Re: Environmental Impact of the Rosemont Mine on Davidson Canyon and Cienega Creek

**RESPONSE TO POWELL ET AL. (2015), "NEW ANALYSIS OF
STORMFLOW AND GROUNDWATER DATA FROM DAVIDSON
CANYON: EVIDENCE FOR INFLUENCE OF STORMWATER
RECHARGE OF GROUNDWATER"**

Seeing the Water for the Models: Pima County's Modeling of Rosemont Mine Impacts on Water Resources in Davidson Canyon Remains Robust Despite Comments by Westland Resources et al. (2016)

Figure 1. Stage and Discharge Data for ALERT Gauge 4310, 7/15 – 11/25/2015

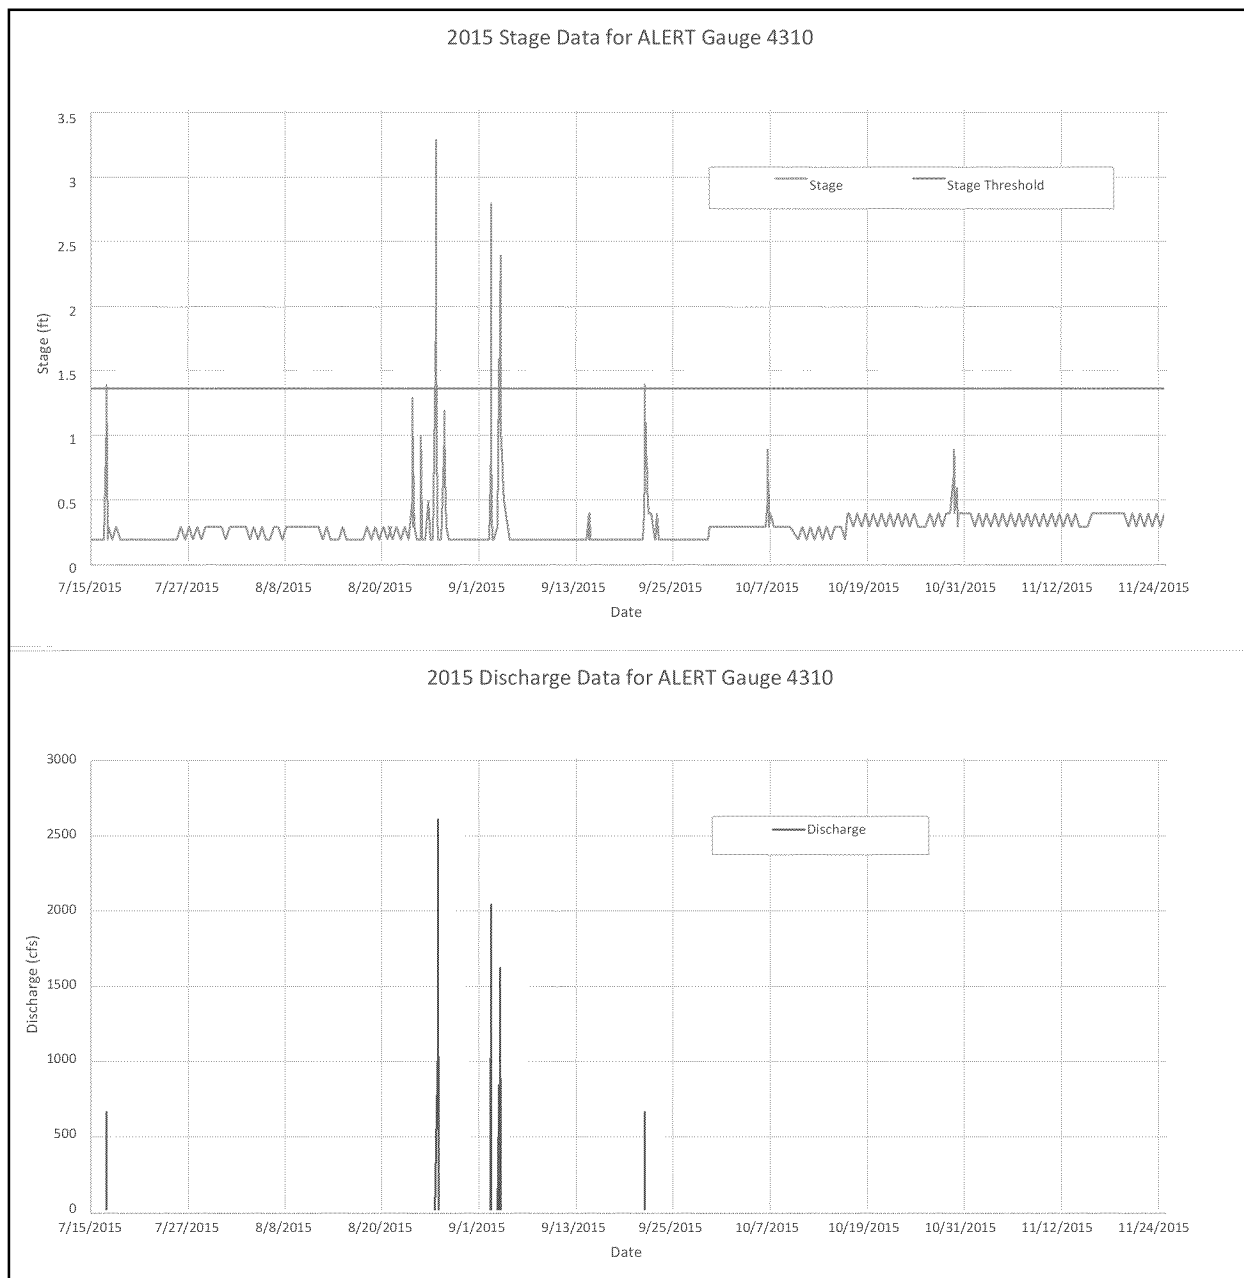
Investigation into the measured stages during 7/15 – 11/25/2015 show that non-zero estimates of discharge were reported for only five (5) runoff hydrographs (shown in green in **Figure 1**) in that period. There were an additional six (6) events with measured stages greater than or equal to 0.5 feet but less than 1.4 feet during 2015 (shown in blue in **Figure 1**). For these six events, discharges of zero (0) cfs were provided in the ALERT data record.

All flows from 7/15 – 11/25/2015 with measured stages less than 1.4 feet were unaccounted. This includes three (3) events between 1.0 foot and 1.3 feet. Discharge during these smaller events is

significant, considering that the rated discharge for a stage of 1.4 feet is 674 cfs. The cumulative volume of runoff from hydrographs with stage magnitudes less than 1.4 feet were not included in the runoff volume computations presented in Powell et al. (2015). The total volume calculated does not account for all runoff at the gauge, and underestimates the actual runoff volumes during the 2015 analysis period. Therefore, Powell et al. (2015) is overestimating the flow contribution from Barrel Canyon. The true runoff contribution of Barrel Canyon as a fraction of Davidson Canyon runoff for these specific flow events cannot be determined with the data available.

Figure 7. Davidson Canyon *flow length* versus *depth to water* at well Davidson #2. Data from Figure 5 of Powell et al. (2014).

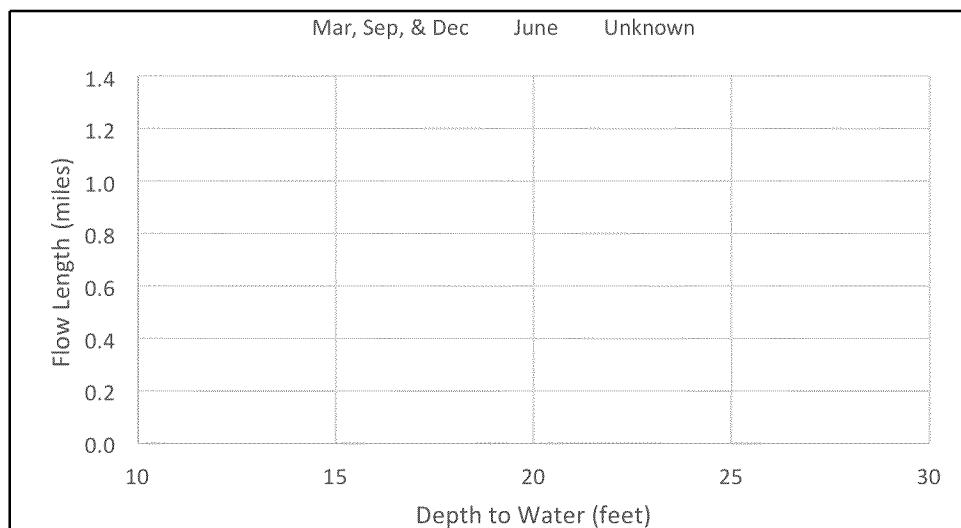
Figure 7 shows the data from Figure 5 of Powell et al. (2014). There are twenty-six data points, with eight from June plotted in red, and one from an unknown date plotted as a green square. The *flow length* is zero for nine of the sample points. For the nine sample points with zero *flow length*, the Powell et al. (2014) depth to water ranges from 20.2 feet to 29.5 feet, with a range of 9.3 feet. The range of *depths to water* for all sample points is 17.5 feet (12.0 to 29.5 feet). The range of *depth to water* for sample points with zero *flow length* covers over half the total range for the sample.

Figure 8. Davidson Canyon *flow length* versus *depth to water* at well Davidson #2. Data from Figure 5 of Powell et al. (2014).

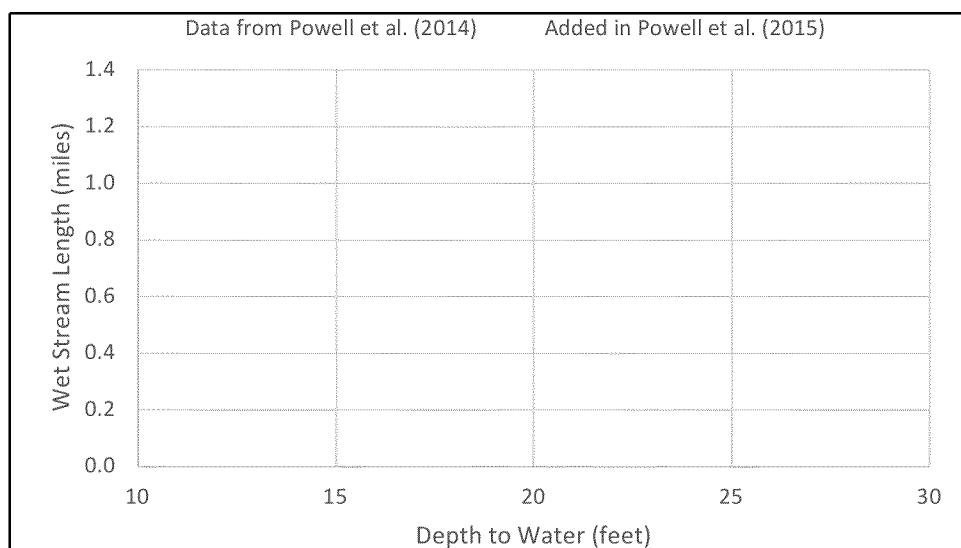
Figure 8 shows the data from Figure 6 of Powell et al. (2015). The points in **Figure 8** are the same as **Figure 7** except that two points (plotted in red) have been added¹. The data in **Figure 8** still include nine sample points with flow length equal to zero, and cannot be modeled using linear regression as was done in both Powell et al. (2014) and Powell et al. (2015).

The sample data were modeled using simple linear regression instead of a model that accounts for censored data. This means that any predictions, such as the 30 percent reduction in *flow length* due to a 0.98-foot increase in depth to water (Powell et al. 2014), are invalid.

Figure 4. Non-truncated dataset of all storm water discharge, including flows of less than 1.4 feet, at ALERT site 4313 in Davidson Canyon for July 15 – November 25, 2015.

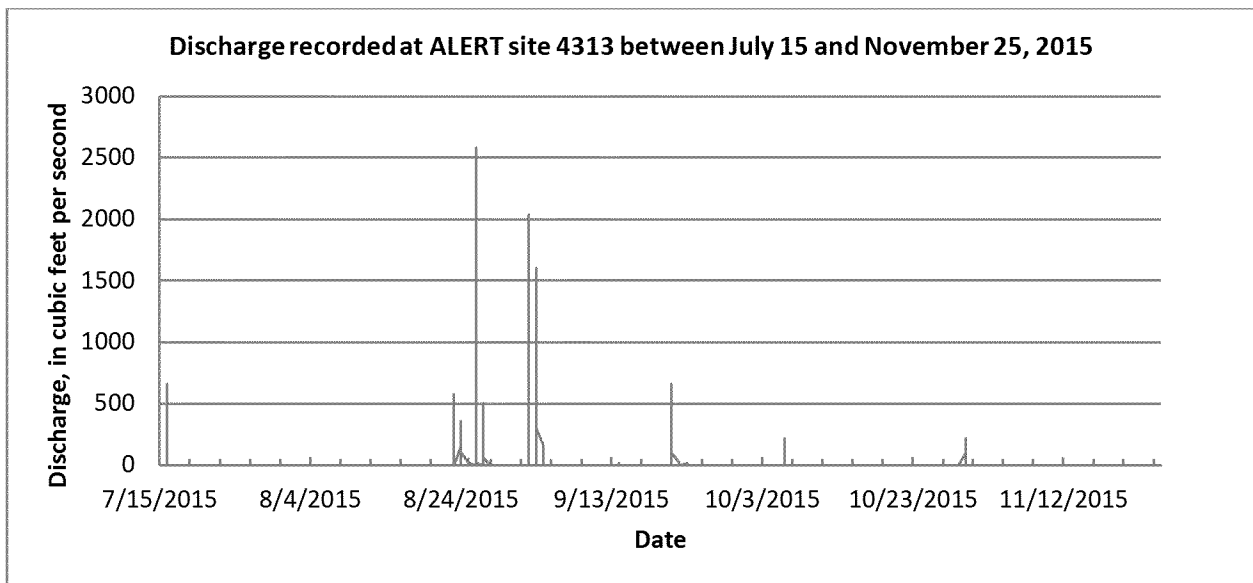
The ratings used to display data on the ALERT website <http://alert.rfcd.pima.gov/perl/pima.pl> are sometimes intentionally truncated for a variety of reasons, and the truncated data set was used in the Powell et. al (2015) report. The complete data set, with discharge estimates for all stage values (including those below 1.4 feet for the period of July 15 – November 25 2015), is included in Figure 4.

Assigning discharge values to low flows increases the total flow volume calculation for the period of July 15 – November 25 of 2015 from 470 acre-feet—as reported in Powell et al. (2015)—to approximately 1600 acre-feet. The 470 acre-feet figure suggested that a disproportionately large percentage of total Davidson Canyon watershed volume is produced by Barrel Canyon. While the higher estimates of surface flow seems to counter our original argument, it is, as pointed out by Westland et al. (2016) a very short data set and the distance between the USGS gage at Barrel Canyon makes quantifying the overall flow contribution from these watersheds a difficult exercise for both Pima County and Rosemont. Neither Pima County nor Westland's analyses can correct the fact that the FEIS has done an inadequate job at describing the proposed Rosemont mine's impact on stormwater and baseflows in Barrel and Davidson canyons.

Figure 5. Runoff volume (acre feet) comparison between Davidson and Barrel canyon showing their close correlation.

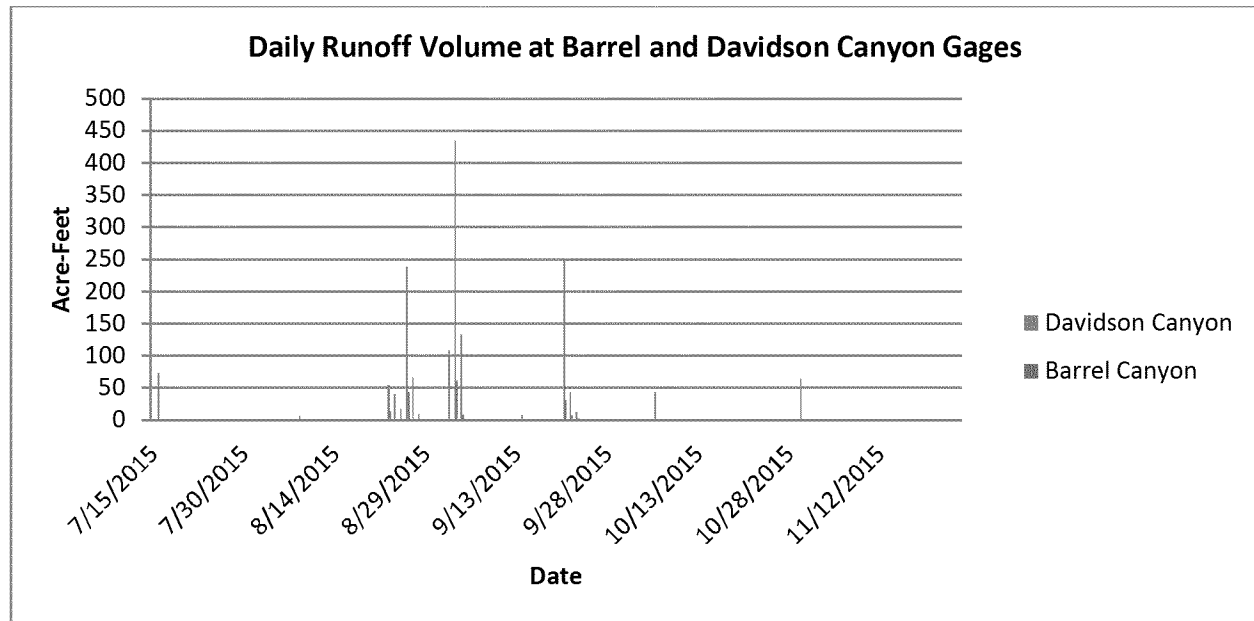
Westland et al. (2016) presents a discussion of runoff variability between the USGS gauge 09484580 located at Barrel Canyon and the ALERT site 4313 streamflow gauge. It is unclear what exactly they are trying to establish but they show that runoff occurred at both locations on the same day on only three occasions during the July 15 – November 25, 2015 sampling period. As noted above, Westland et al. (2016) used an incomplete record of discharge for their analysis. In actuality, when using the complete dataset (Figure 5), it is clear that 70-percent of runoff events measured at the Davidson Canyon ALERT gage occurred on days where discharge was also recorded at Barrel Canyon. Barrel Canyon recorded more days of runoff than Davidson Canyon, but 50-percent of the runoff events recorded at Barrel Canyon also corresponded with days where runoff was measured at Davidson Canyon. As we have already acknowledged and pointed out, this temporally narrow data set is not sufficient to fully describe long-term watershed characteristics, but it does suggest that runoff events in the upper and lower watershed are not as temporally isolated as Westland et al. (2016) claim.

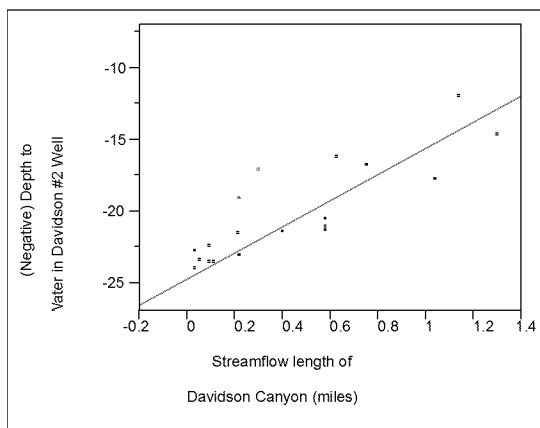
A primary concern to Westland et al. (2016) is that Powell et al. (2015) used a linear model with “censored response variables”. We appreciate the authors pointing out this statistical minutiae to us and thus we have rerun the analysis without the zero values and with the two new values from late 2015. Figure 5 is the result of the re-run model using simple linear regression, which accounts for 71% of the variation in the data. Had Westland et al. (2016) done these analyses themselves, they would have seen that removing the zero values had no impact on the model outcome.
